NORTHEAST UTILITIES

April 14, 1982

MILLSTONE NUCLEAR POWER STATION, UNIT NO. 2
ADDITIONAL INFORMATION - INSERVICE
INSPECTION AND TESTING PROGRAM

FIGURE 1

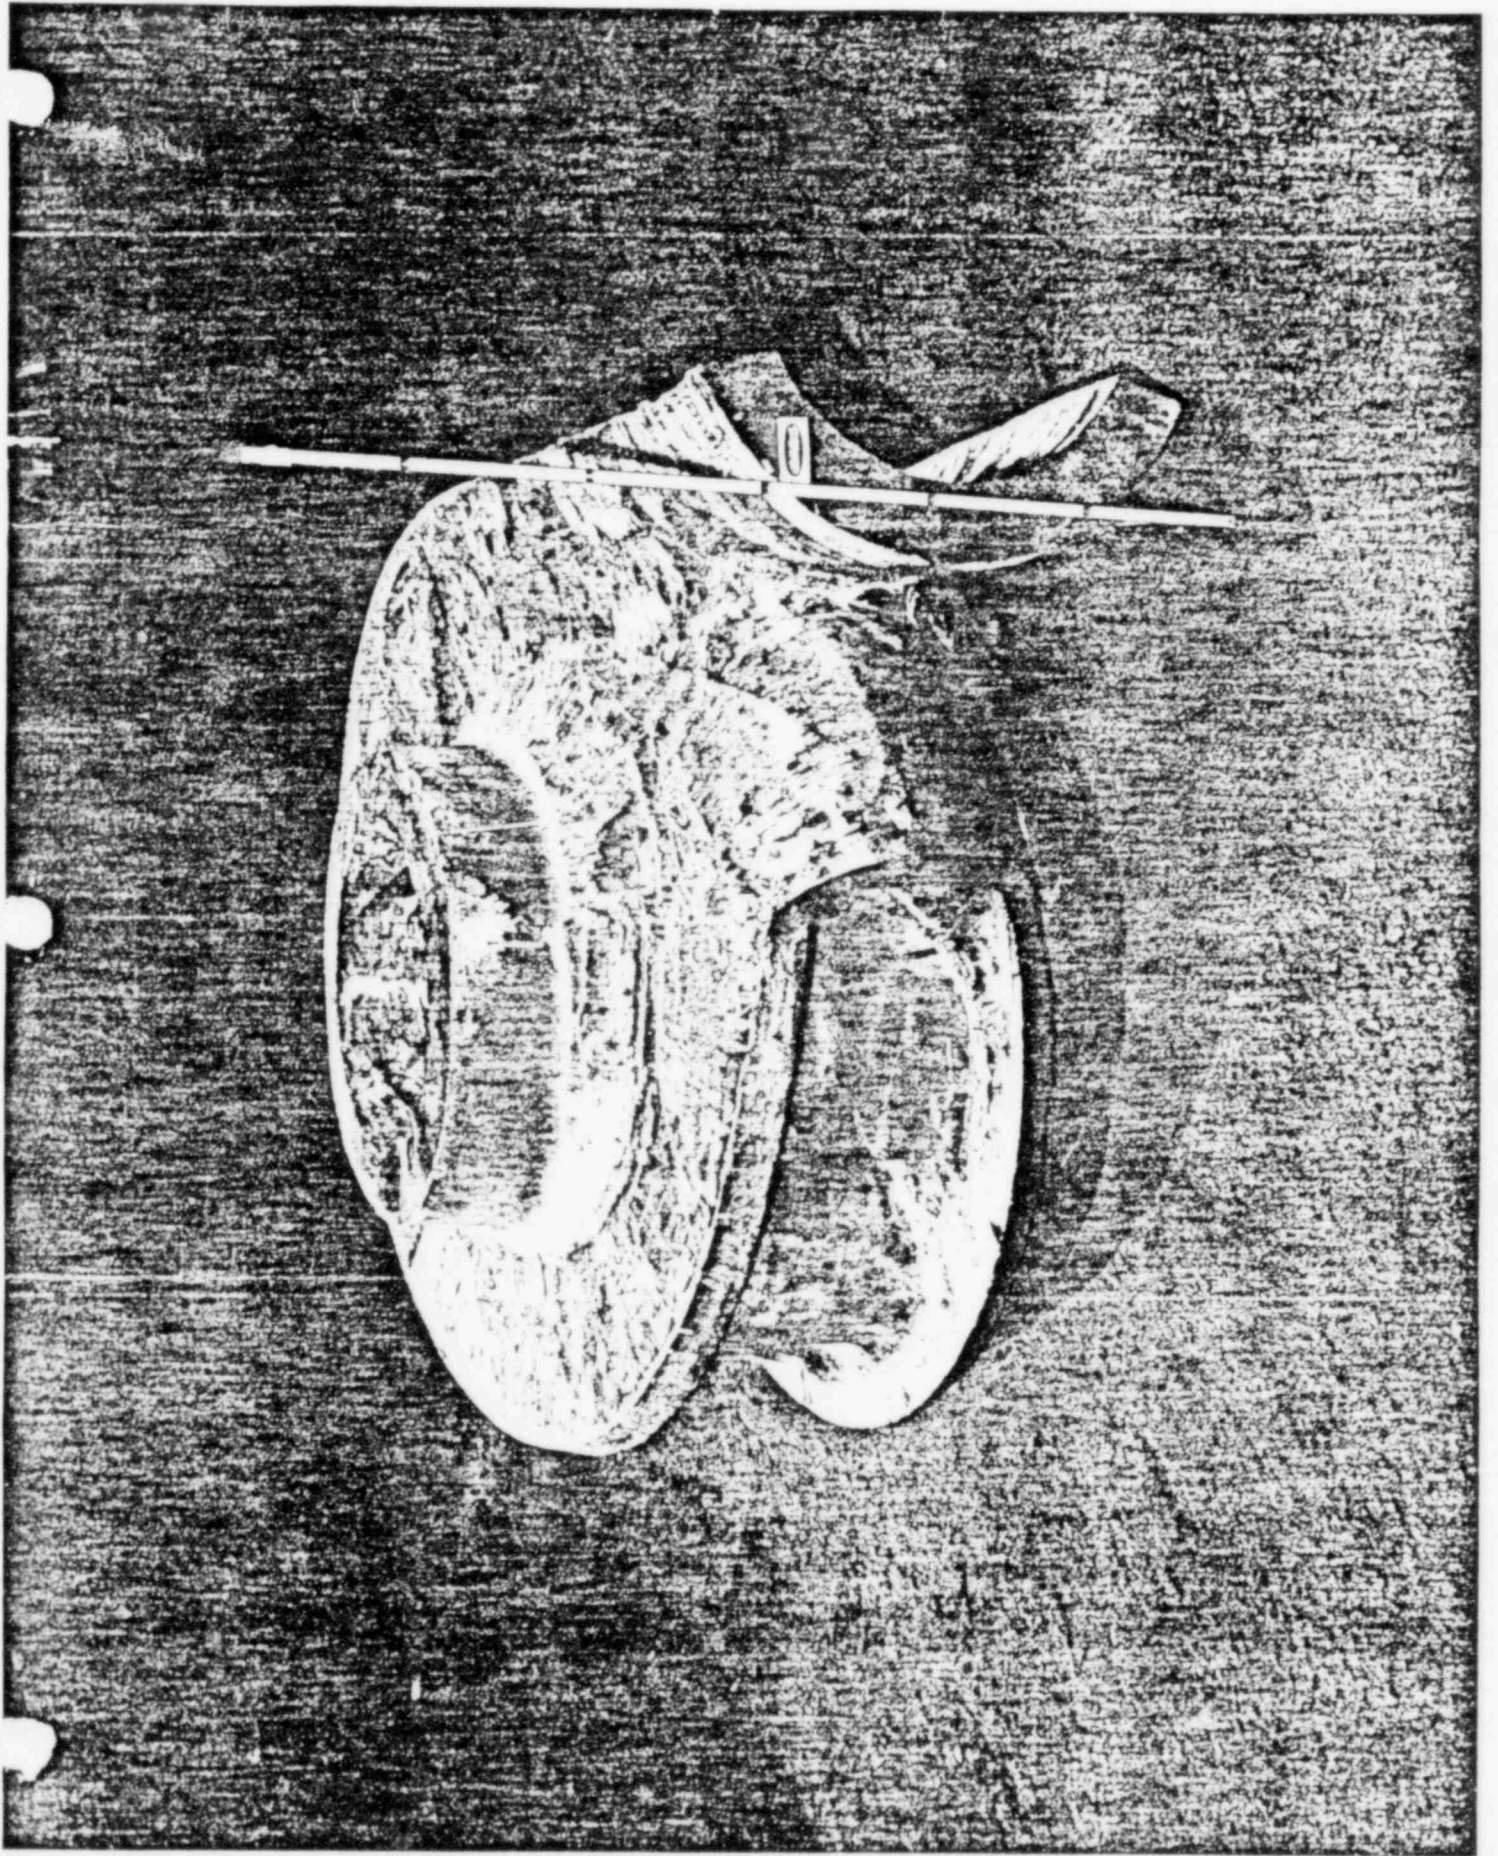
3. In regards to casing welds on recirculating coolant pumps, have you made any visual inservice inspections of these pumps? If so, document results by reference to previous NRC submittals? Have you identified a feasible method for volumetric inspection and are you prepared to commit to doing it by 1985?

No visual inservice inspections have been performed on the Millstone Unit No. 2 reactor coolant pumps (RCP's) to date. Millstone Unit No. 2 utilizes Byron-Jackson-Borg-Warner Type DFSS pumps manufactured in 1972. Figures 1 and 2 illustrate the dual casings which comprise these pumps. Due to this double wall construction, use of the MINAC for examinations is not possible since placement of either the radiographic source or film on the inside of the welds under examination is impossible.

Ultrasonic examination of these heavy wall castings using current techniques would be of questionable benefit due to the grainsize and back reflection problems.

The reactor coolant pumps presently being examined using the MINAC are of a different design which enables single wall radiographs. No deterioration of pump casings has been reported to date. The examinations result in large expenditures in time and radiation exposure and are extremely expensive.

With the current state-of-the-art, NNECO hereby requests relief from the ISI requirements for RCP's since no valid examination technique is available. If, before 1985, a reasonable examination technique is developed for Byron-Jackson type pumps, NNECO will reevaluate this relief request.
